Re: City of Napavine – Washington Street Improvements
BNSF Intertie

PETITION TO INSTALL INTER-TIE
WITH TRAFFIC SIGNAL

Subject: Washington Street Railroad Preemption Sequence
City of Napavine, Washington

Figure 1. Observed Dispersion Distribution for 320-Foot Queue.

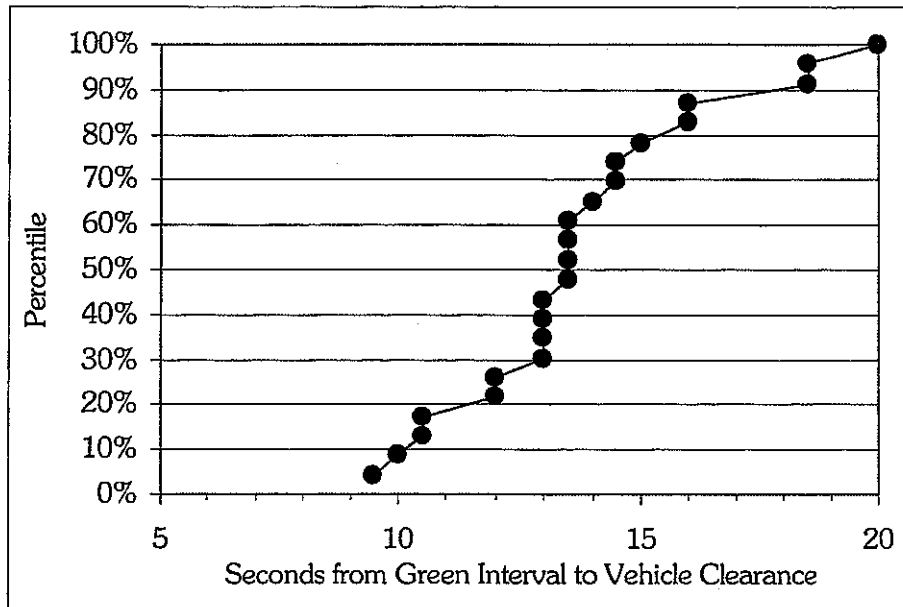
TSI evaluated times necessary for automobiles to evacuate the railroad tracks. This was based on a review of published research^{1,2,3}, observation of queue dispersal at similar intersections, and use of traffic simulation software. Figure 1 illustrates observed queue dispersal times 320 feet from the stop line at a similar intersection experiencing more frequent queuing.

We determined that an eastbound vehicle queued on the tracks would virtually always begin motion no more than 21 seconds after the green interval begins (only 16 seconds is required westbound, for the Birch Street signal). This vehicle should be off the tracks before the gates descend upon it. We believe an appropriate design time by which the vehicle should be in motion is the time the gates begin their descent, which could occur 15 to 20 seconds before train arrival. Therefore, we target this automobile to be in motion 20 seconds before train arrival. This target time was selected in part on the fact it will be exceedingly rare for a queuing event to occur, based on near-term traffic volume projections.
